Product Change Notification: CAA-13UUGL810

CCB 6729 Final Notice: Qualification of ASEM as an additional assembly site for selected KSZ8001 and KSZ8721 device families available in 48L LQFP (7x7x1.4mm) package.

Pre and Post Change Summary

LEAD FRAME COMPARISON

OSE

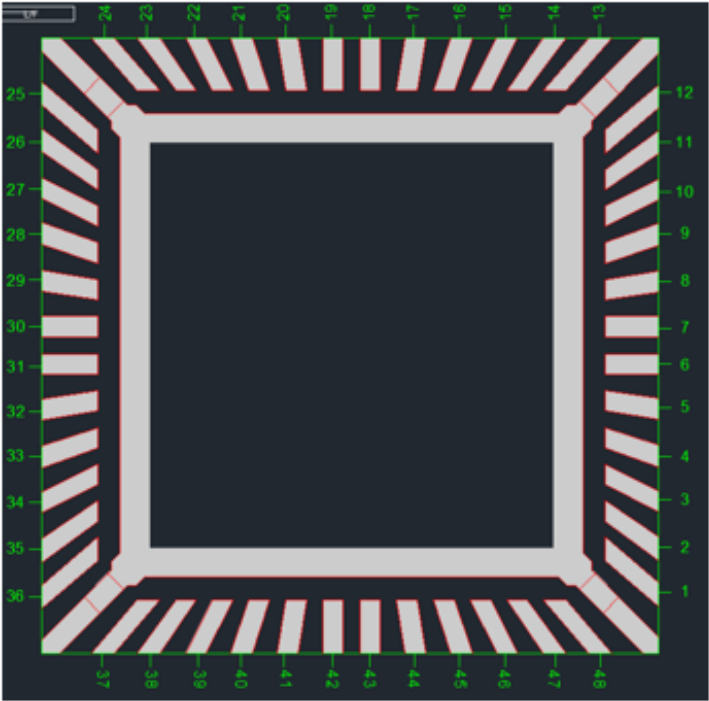
Wire Material	Au
Lead Frame Material	C7025
Lead-Frame Paddle Size	160x160 mil

ASEM

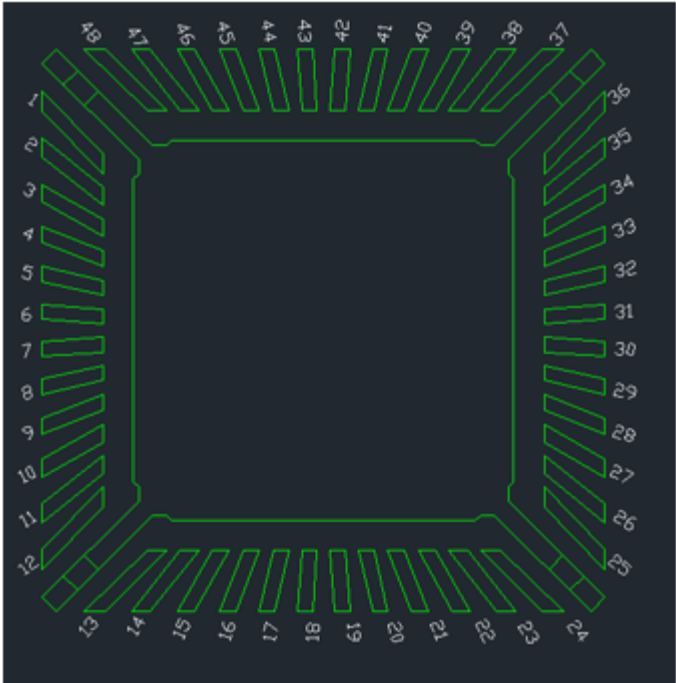
Wire Material	Au
Lead Frame Material	C7025
Lead-Frame Paddle Size	150X150 mil
